DESIGN COMMISSION REGULAR HYBRID MEETING AGENDA

TITLE:	DCB 25-04: Design Standard Review (DSR) 24-004 Study Session for Herzl Ner-Tamid Conservative Congregation Preschool-8 Project	<input checked="" type="checkbox"/> Discussion Only <input type="checkbox"/> Action Needed: <input type="checkbox"/> Motion <input type="checkbox"/> Recommendation
RECOMMENDED ACTION:	N/A

On April 4, 2024, the Applicant applied for a study session with the Design Commission to review a proposal to construct a three-story, mixed-use building, housing a preschool and K-8 private school on the lower levels and rental office space on the upper level and a half. Parking, trash, utilities, and pedestrian paths are located on adjacent parcels owned by Herzl Ner-Tamid Conservative Congregation (HNT). Applicants for Design Commission Design Review are required to take part in a study session with the Design Commission prior to public hearing pursuant to Mercer Island City Code (MICC) 19.15.220(C)(2)(a); this study session fills this requirement.

A-011

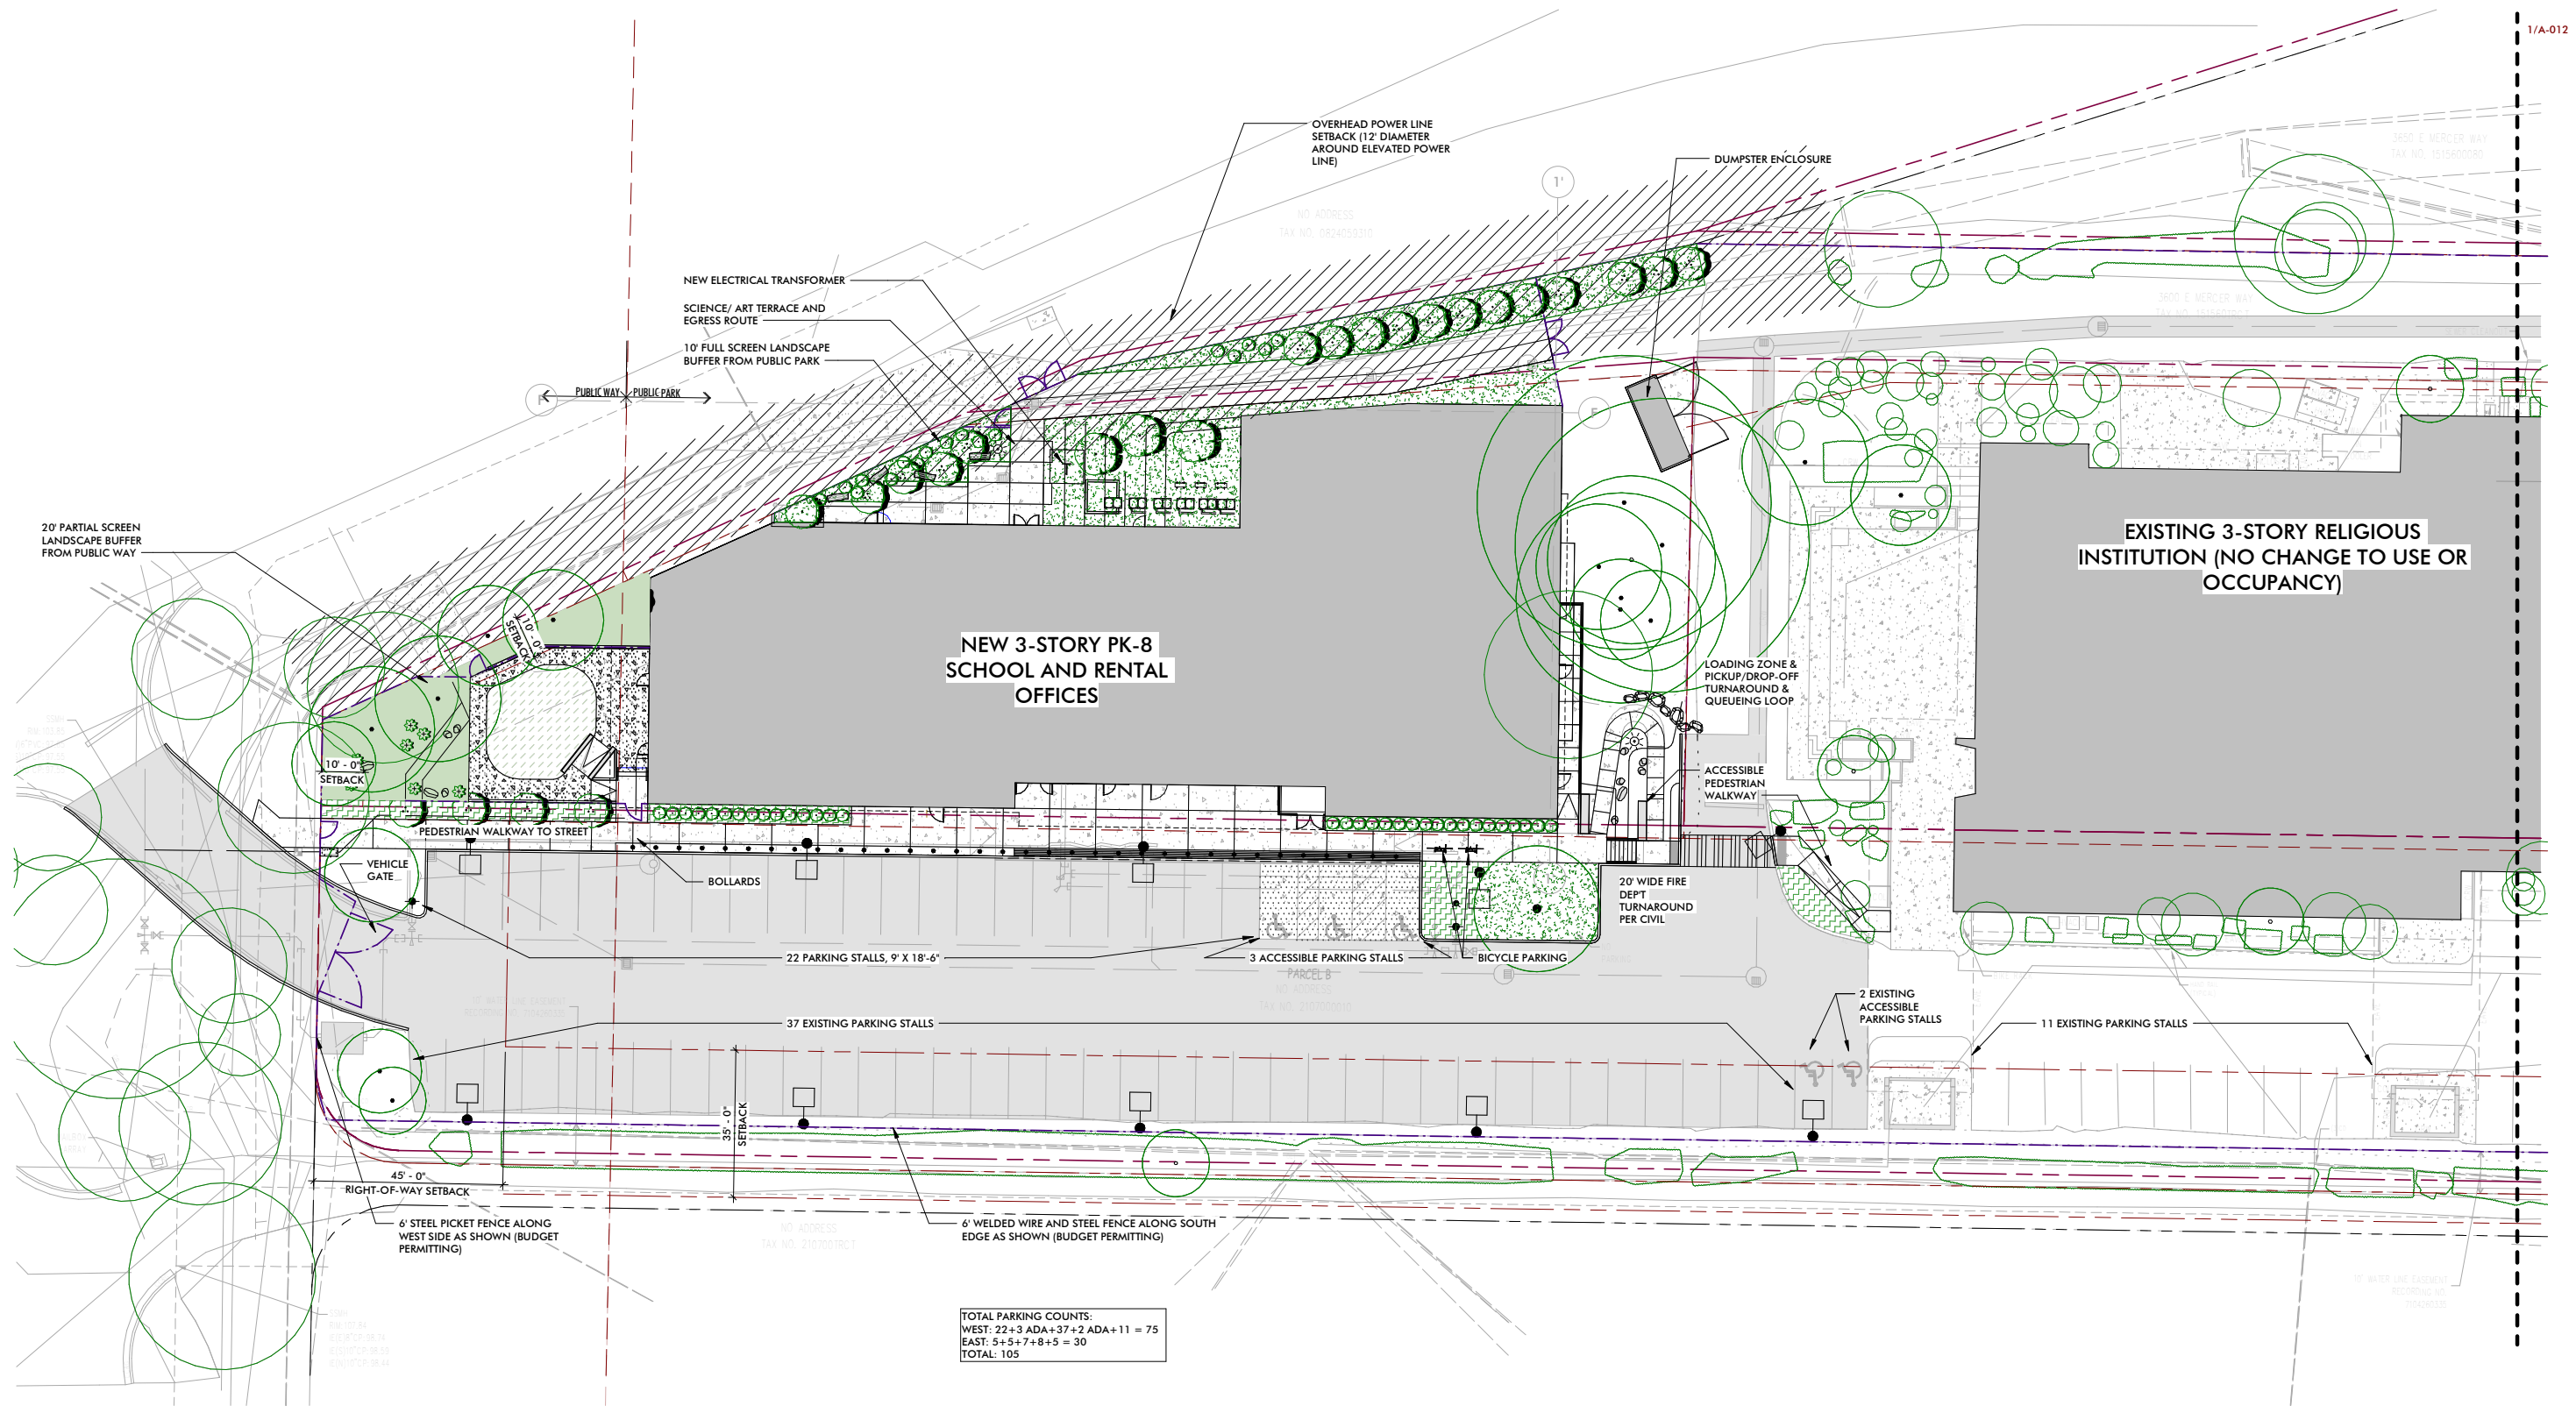
Preliminary Staff Analysis: The applicant must demonstrate that screening requirements have been met. Sheet A-011 of the plan set shows 20' partial screening from the public way on the west side of the subject property. The applicant applied perimeter width averaging where plant material would be clustered to screen parking areas and structures from adjacent public way and significant trees outside of the building footprint would be retained. The applicant must demonstrate that the minimum landscape area requirements in MICC 19.12.040(B)(4) and the objectives of this section are met.

6 HEIGHT DIAGRAM

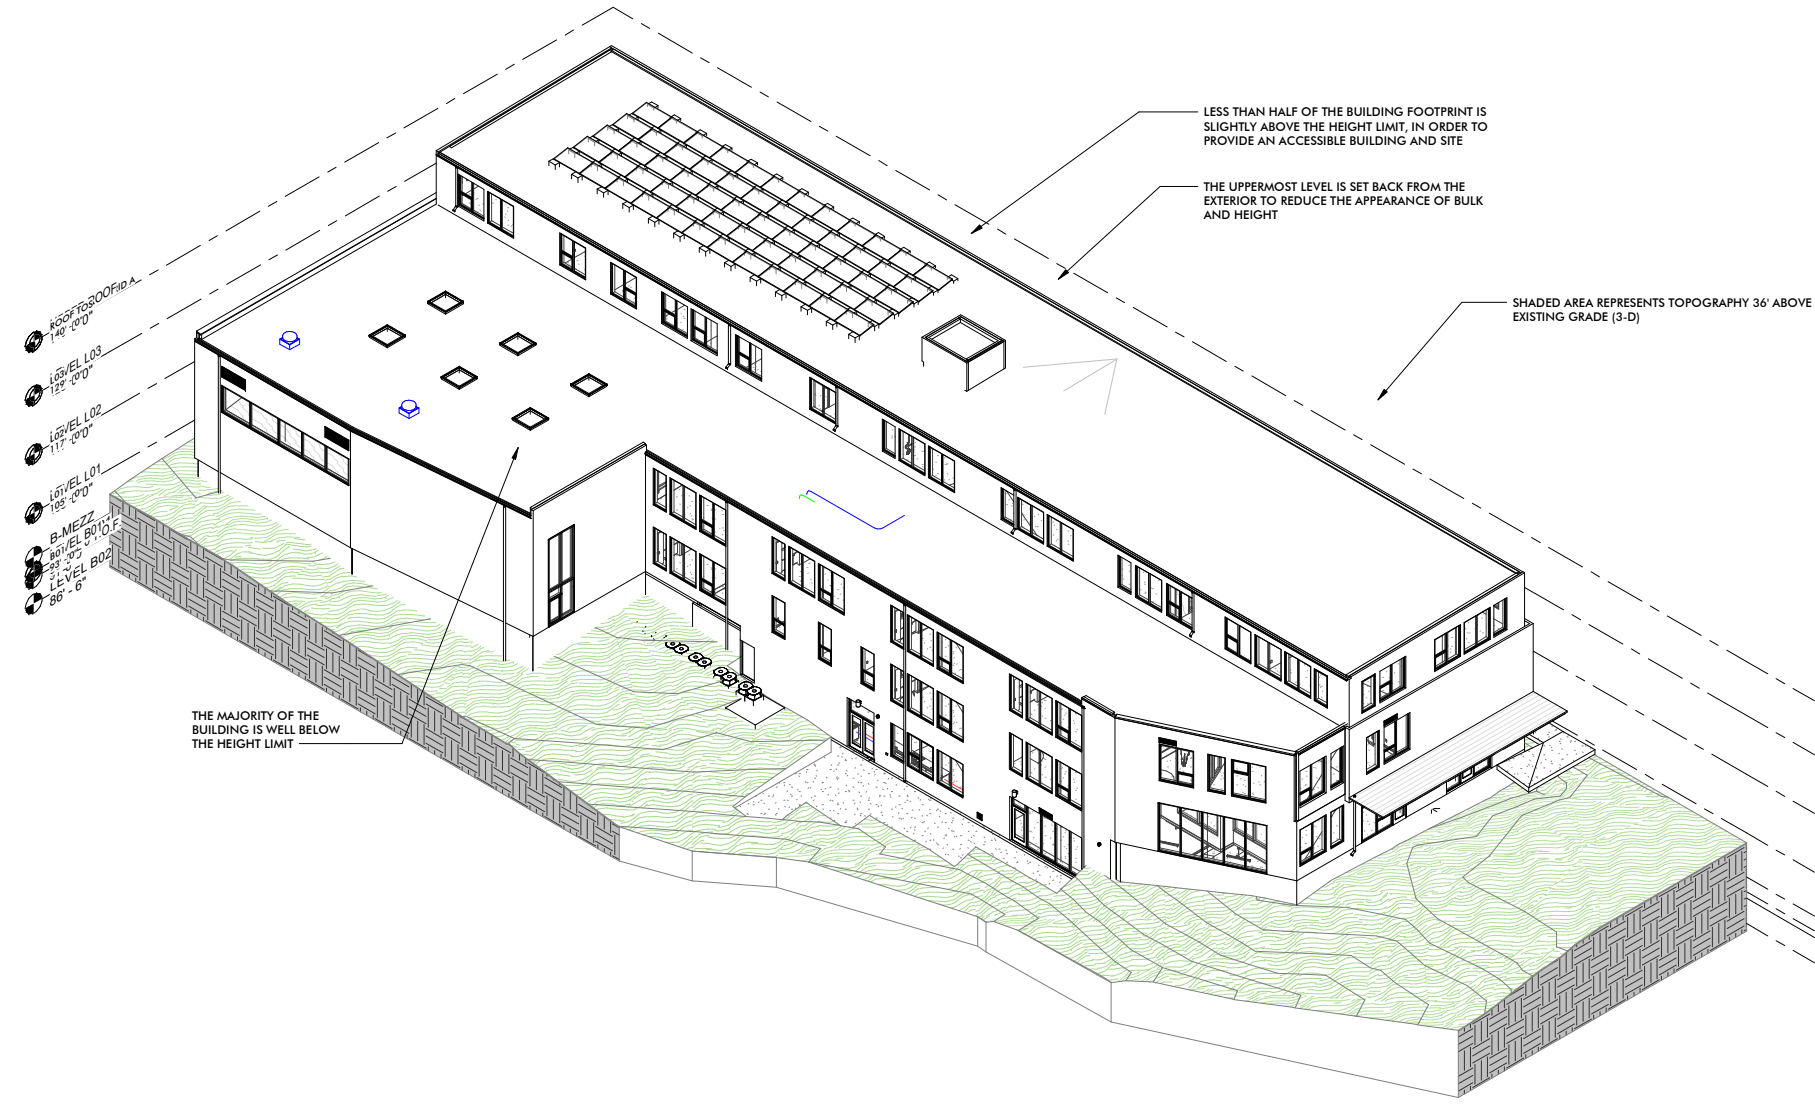
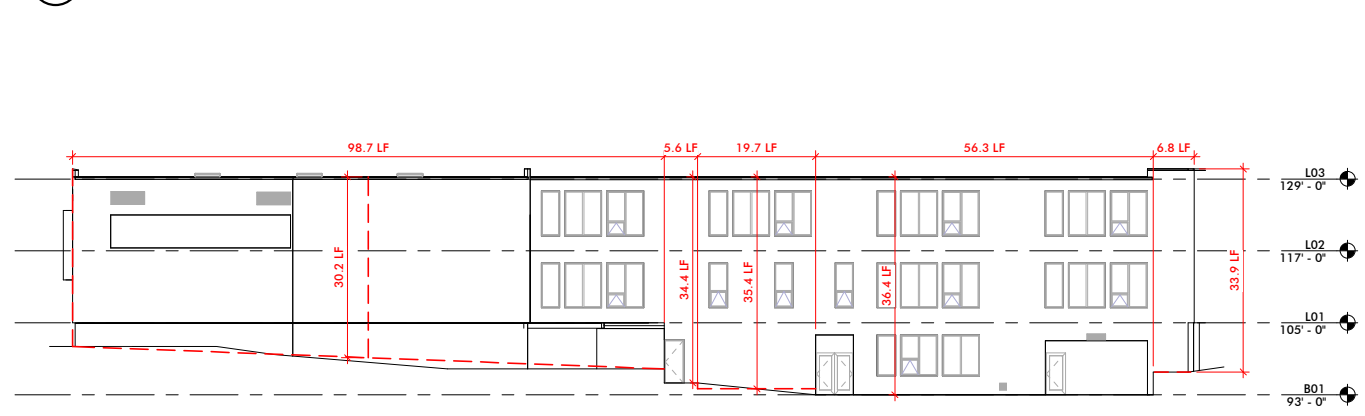
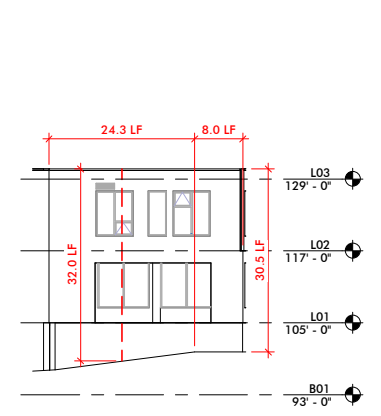
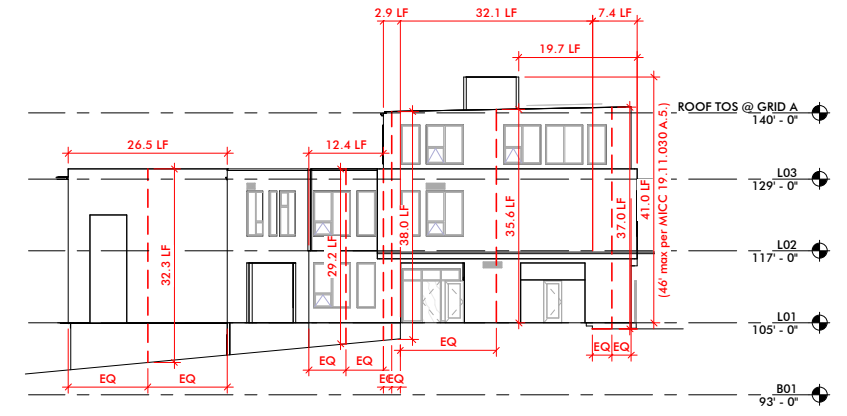
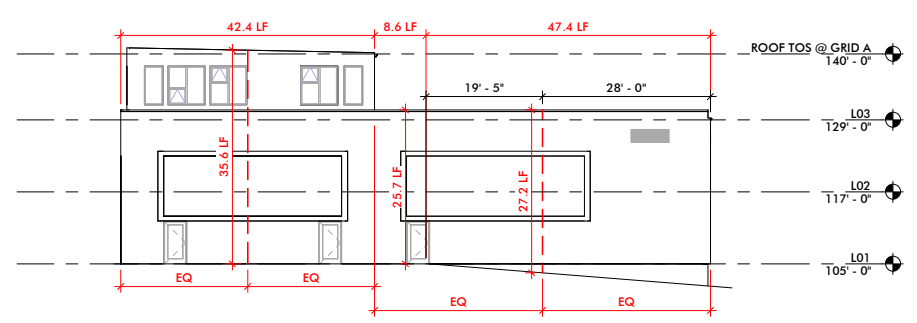
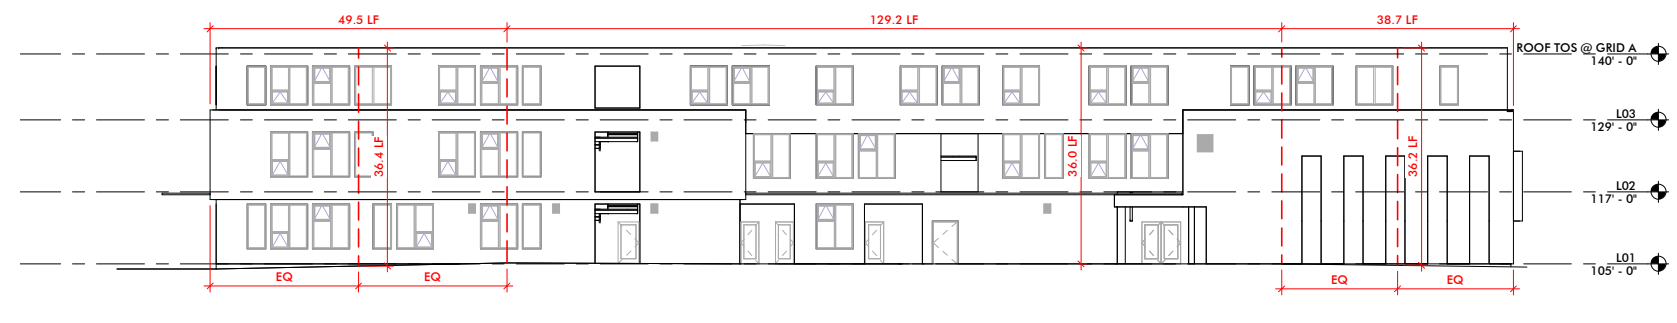
1. Review and discuss height diagram and calculations.
 - a. We are below the height limit per the language of 19.11.030 (A)(3), but there is some room for discretion. The site is extremely long, and we are trying to meet both accessibility and existing grades. Emphasis added.

L-201

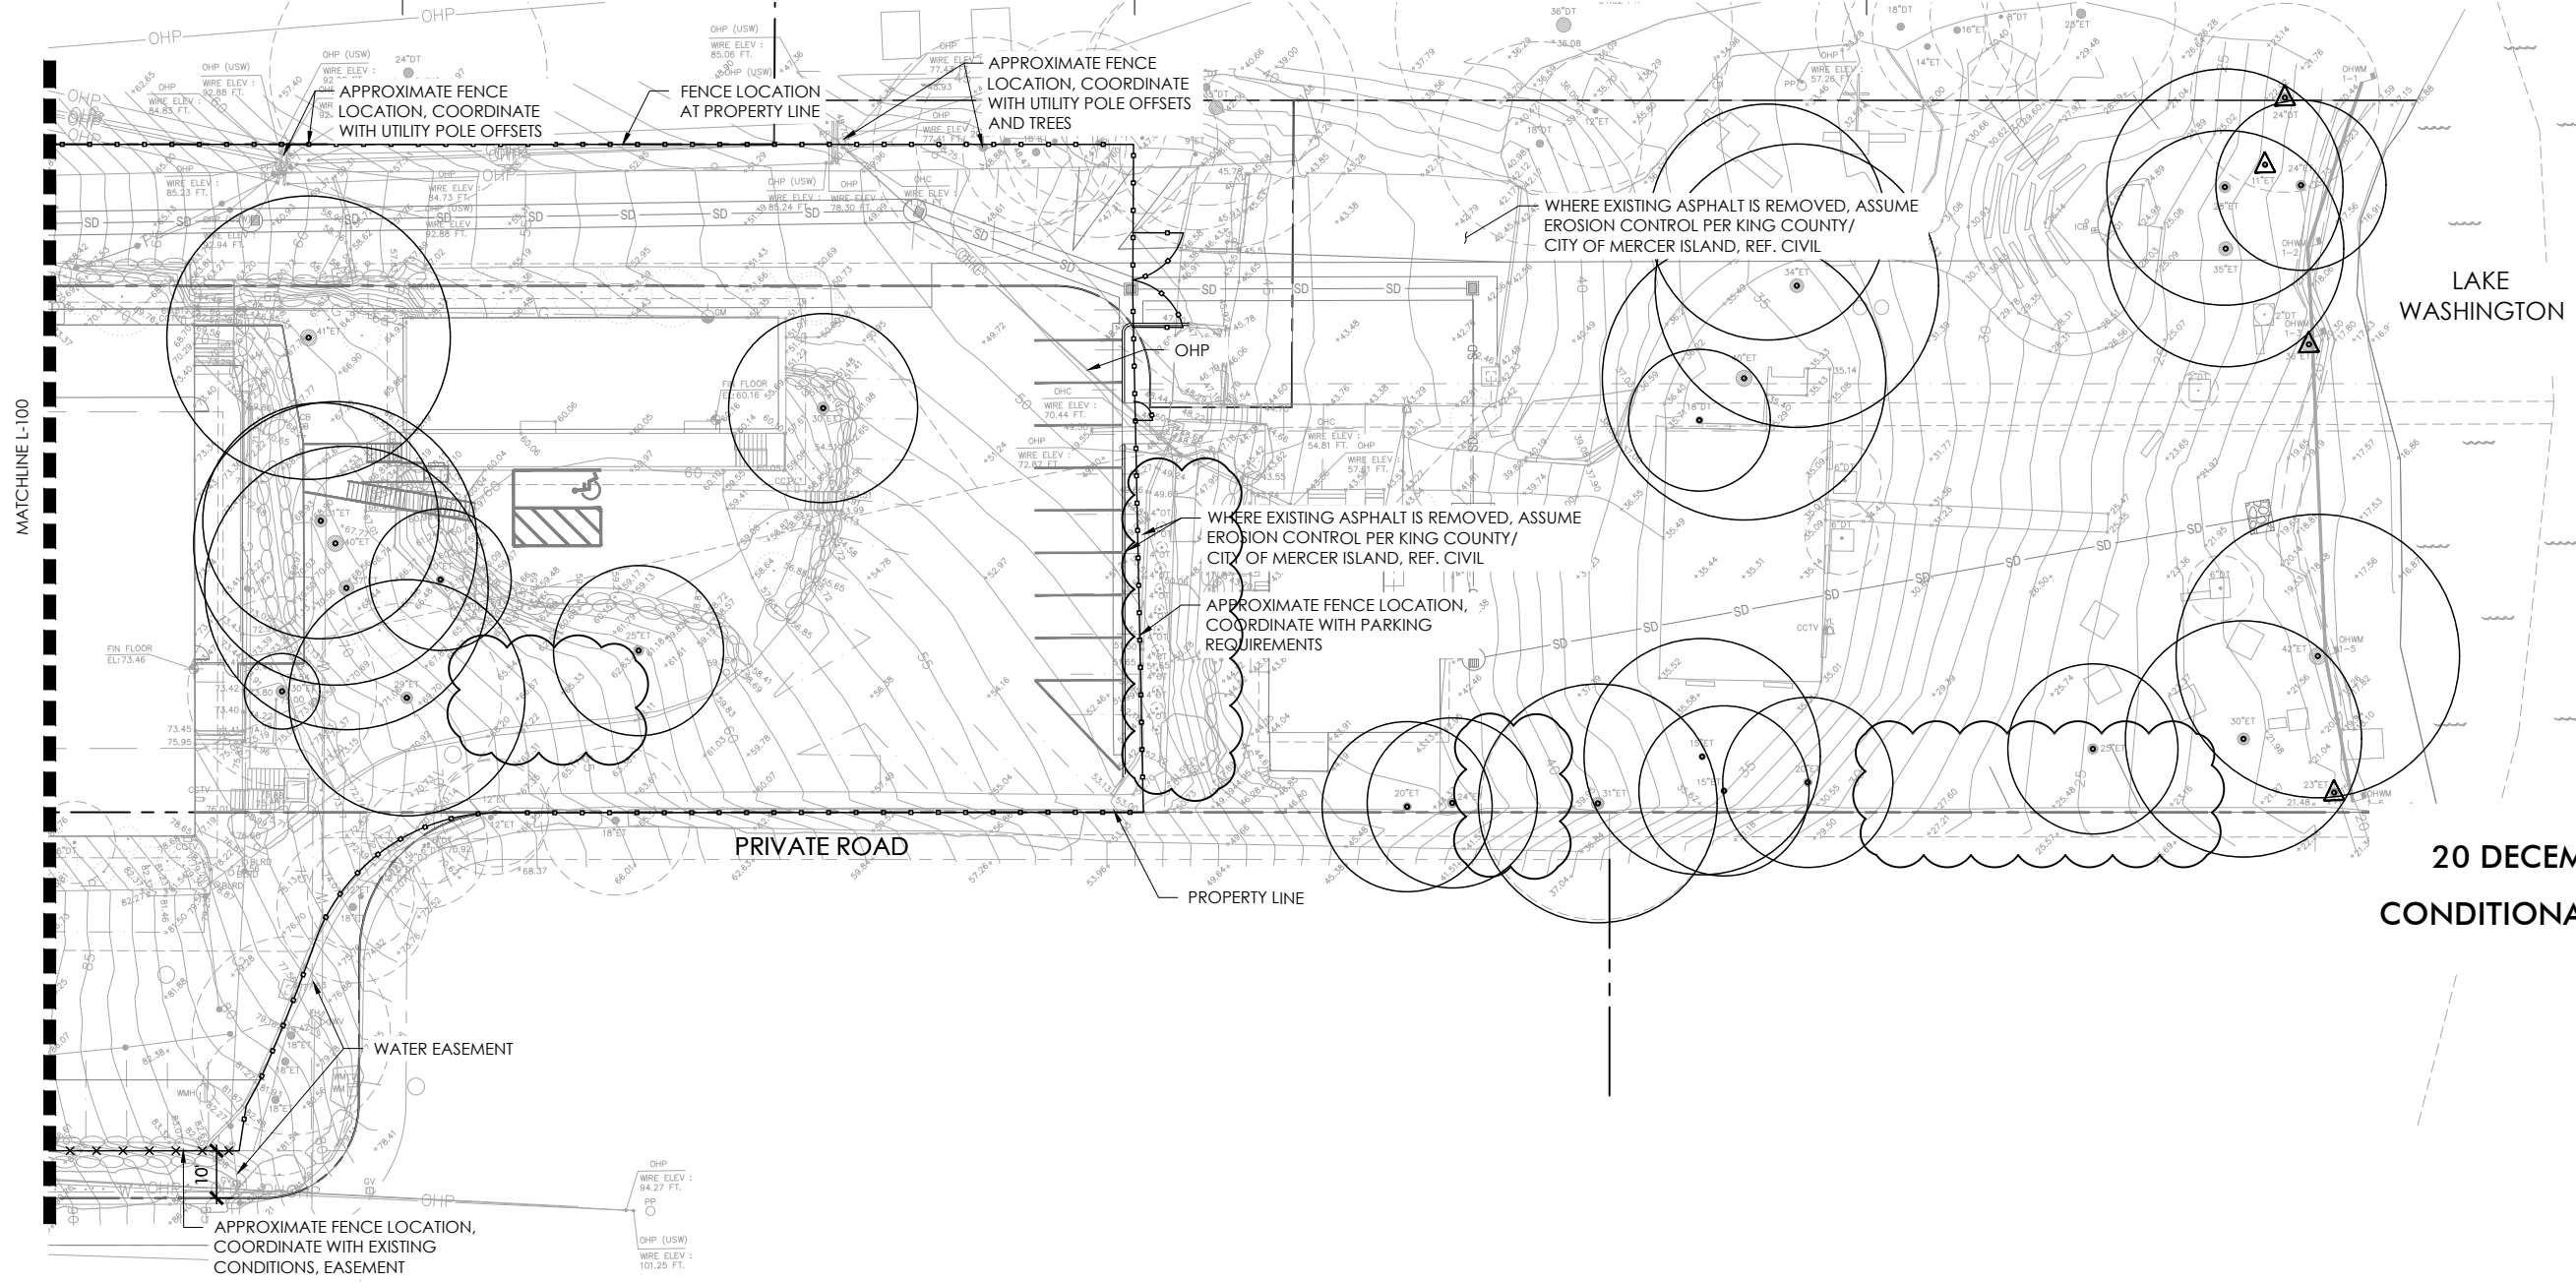
Preliminary Staff Analysis: The landscape plan on Sheet L-201 of the plan set includes screening from adjoining properties and public ways on the north and west property lines.

Preliminary Staff Analysis: The proposed plant schedule on Sheet L-201 of the plan set includes native species like Vine Maple, Cascara, Western Sword Fern, and Huckleberry. Ground cover is proposed.
